**ZONING MAP CHANGE
STAFF REPORT**

Owner / Applicant: Summer Creek Station/Wilson Stonaker, LLC

Site Location: 5400-5600 blocks Columbus Trail and Sycamore School Road
Mapsco: 102M

SUMMER CREEK STATION RETAIL			
PD SITE PLAN			
SEC CHISHOLM TRAIL PKWY & SYCAMORE SCHOOL RD			
DESIGNED:	JBB	PROJECT NO:	SHEET:
DRAWN:	JBB	DATE:	1 OF 1
CHECKED:	CMB	07-27-16

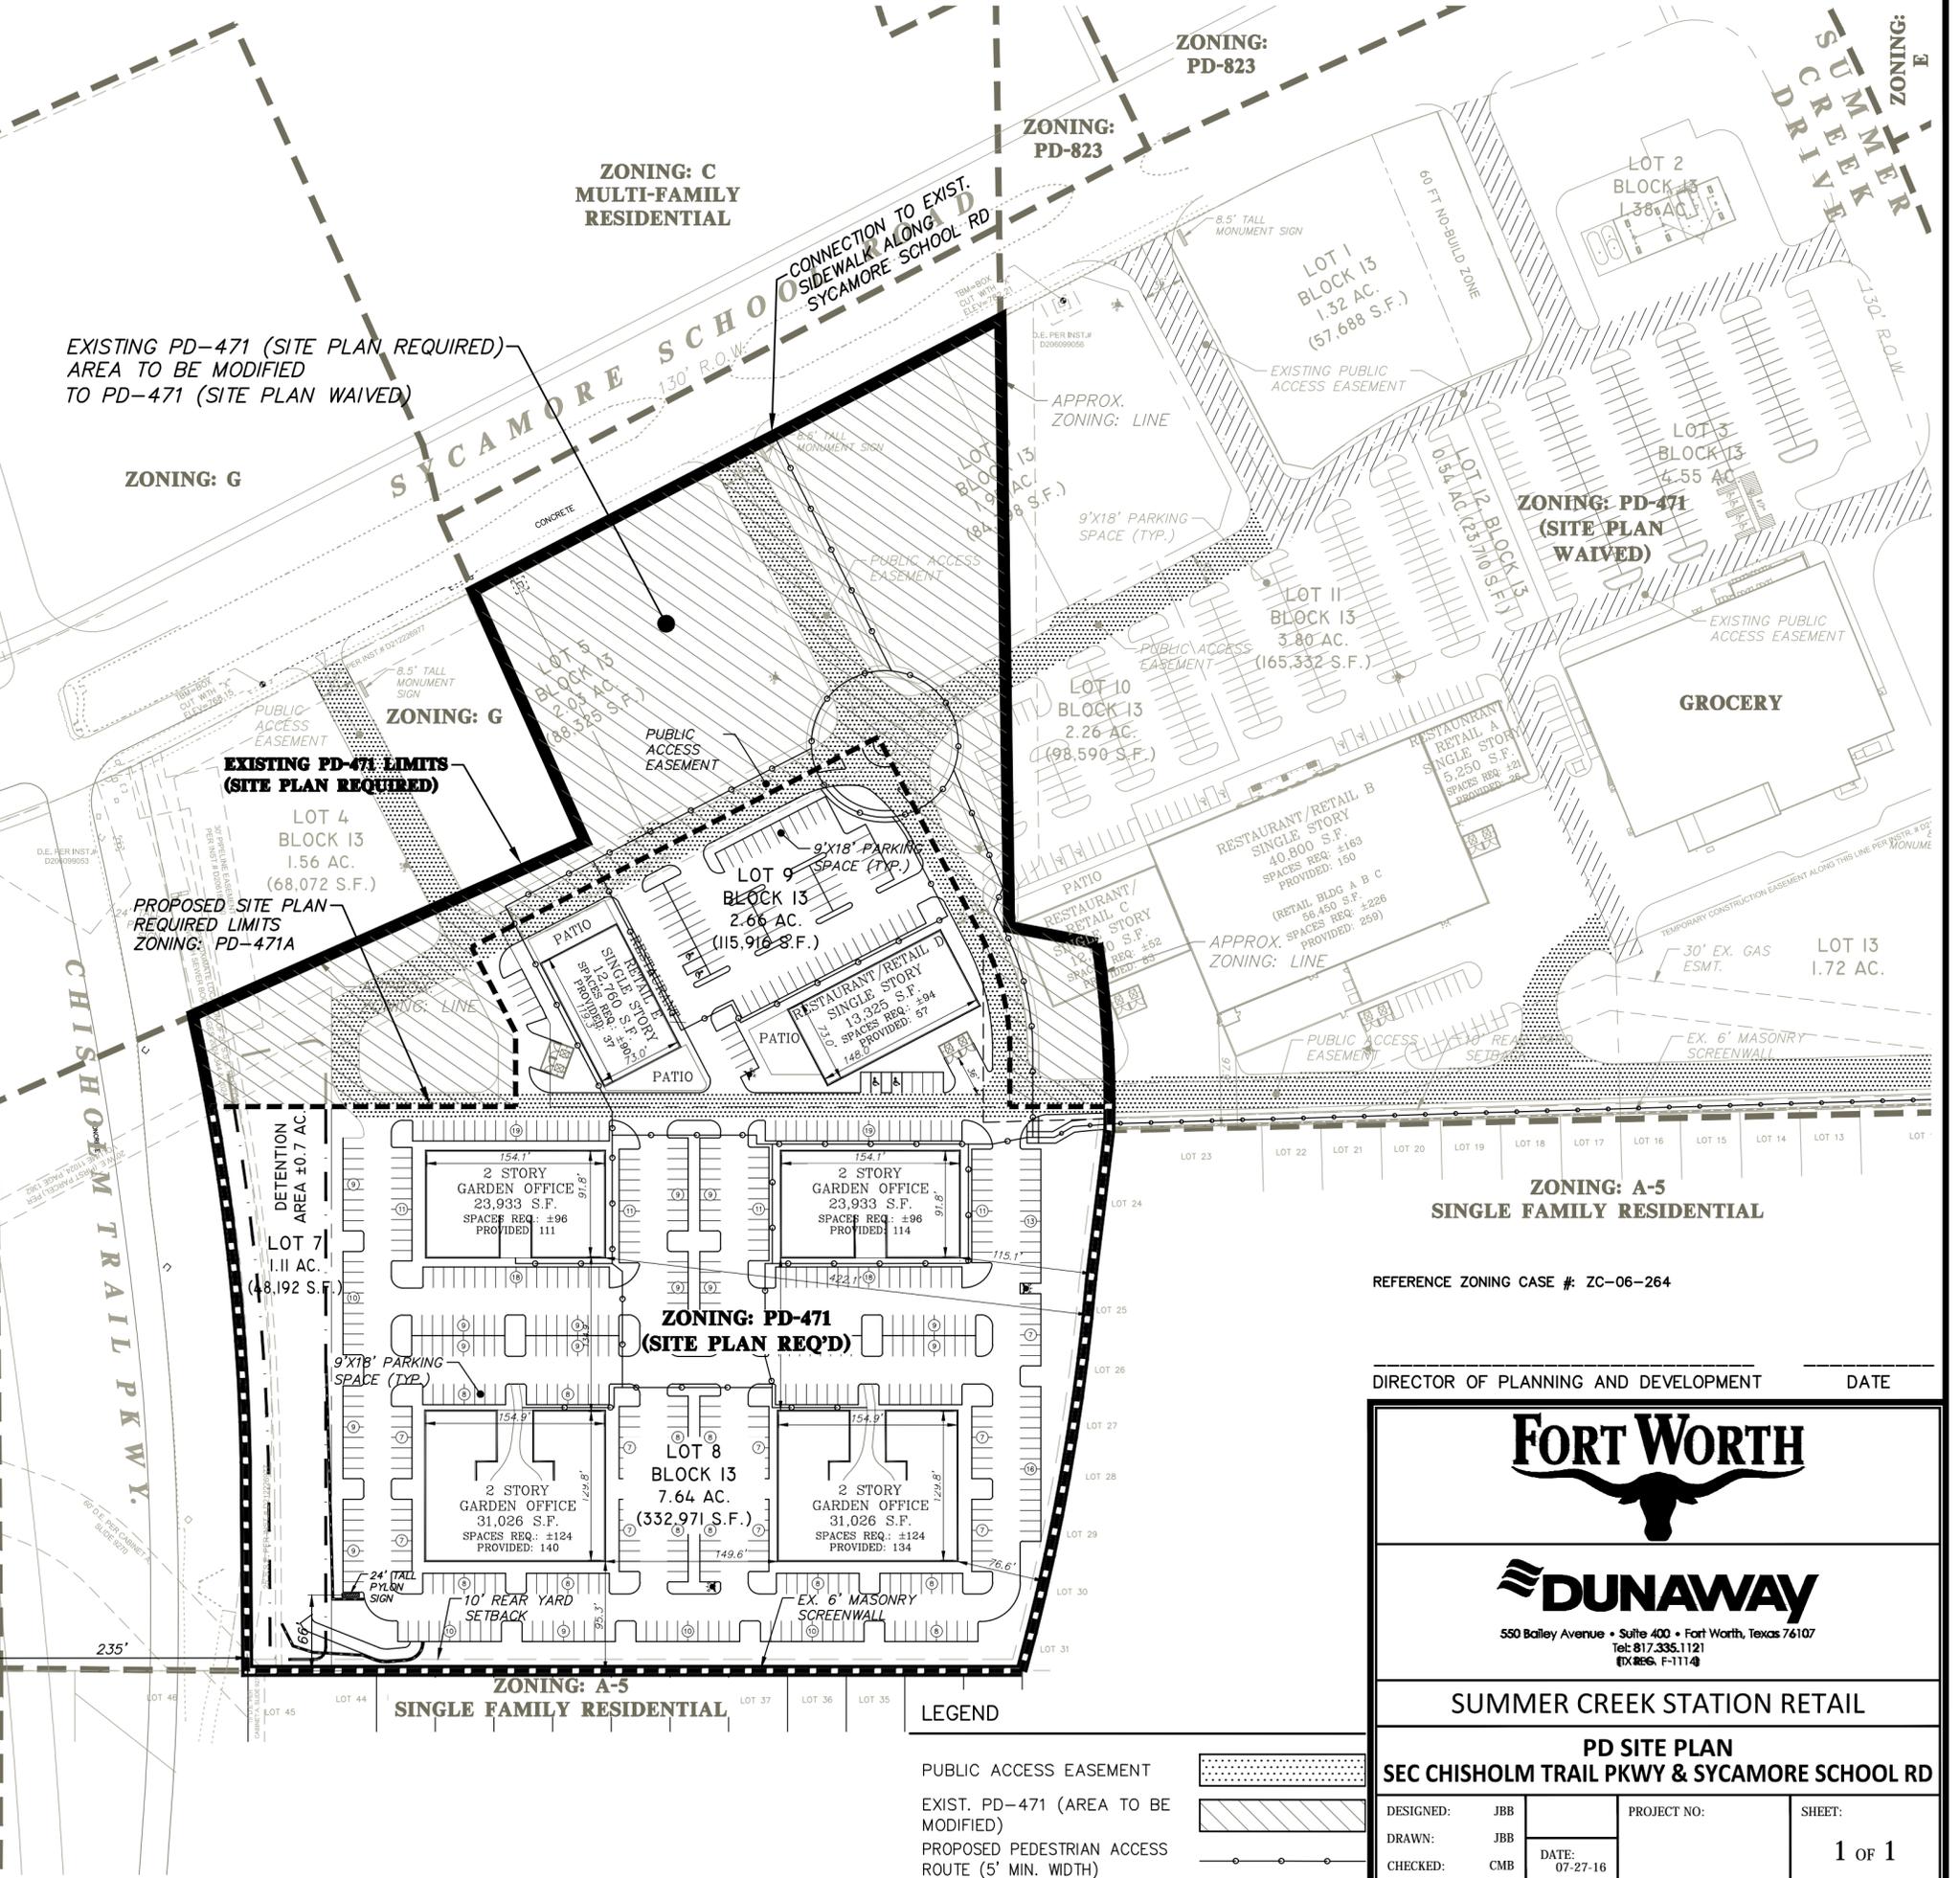
The revised site plan as submitted is not in general compliance with the zoning regulations.

1. The parking counts for the retail/restaurant use buildings at an estimated 50%/50% of future used space do not comply with the required ratios. **(Waivers required)**

- 0505 – Special Needs Note – {Show public pedestrian access easements for sidewalks within the development area.}
- 0573 – Property Location - Show distance(s) from property corner(s) to nearest identifiable street, railroad or other intersection.

- 0151 – TXDOT Permit - TXDOT permit is required for work in and along State ROW. Street connections to TXDOT ROW is contingent upon TXDOT approval. TXDOT approval required for any proposed interchanges and/or driveway access to TXDOT facilities. A driveway permit is required to show Lot 7 has access to Chisholm Trail Parkway. This lot does not have access to a public street or a public access easement as shown.

- 0220 – Median Openings - Median openings will be reviewed by TPW at construction plans submittal. Median openings must be coordinated with surrounding developments. The existing medians on Sycamore School Rd. and Summer Creek have been set by the previous developments. No additional median cuts will be permitted for this project.

- 0271 – Public Access Easement - Access easements shall comply with the requirements of Section 31-106 (Street Standards) I (Access Easement Design Standards (Public Access Easements, Reciprocal access Easements, Private Drives or Ways) of the Subdivision Ordinance. Access easements are privately maintained but constructed to city street standards that are open to unrestricted and irrevocable public access and serve two or more lots each having a minimum of 100 feet of frontage as their primary means of access. Provide the widths of the public access easements shown on the plat Remove the variable width and provide the widths as the easements transition.

- 0505 – Special Needs Note – {The easternmost north/south public access easement east of Lot 6, Block 13 does not connect to right-of-way or public access easements. The east/west public access easement south of Lot 6, Block 13 does not tie into right-of-way or a public access easement. The existing public access easement along Lot 11 and Lot 12 does not tie into right-of-way or a public access easement.
Verify the limits of the public access easement and connect the easements to either the existing public access easements or the new proposed adjacent public access easements.}

- 0402 – Public Open Space Easement - A triangular 10’x10’ POSE (Public Open Space Easement), shall be provided at the intersection.

Traffic Circle design to be reviewed with construction plans. As shown does not comply with standards.

Provide drive aisle widths

0221 – Street Centerline Offsets - Street centerlines offset(s) as shown are unacceptable. Centerline offsets shall be at least 135' between local streets. Greater centerline offsets may be required by the City Traffic Engineer. The intersection of the public access easements and the driveway location northeast of Lot 8 creates a substandard offset. Align the southern stub with the proposed public access easement or locate the driveway a minimum of 75ft. (edge to edge) from the intersection of the public access easements.
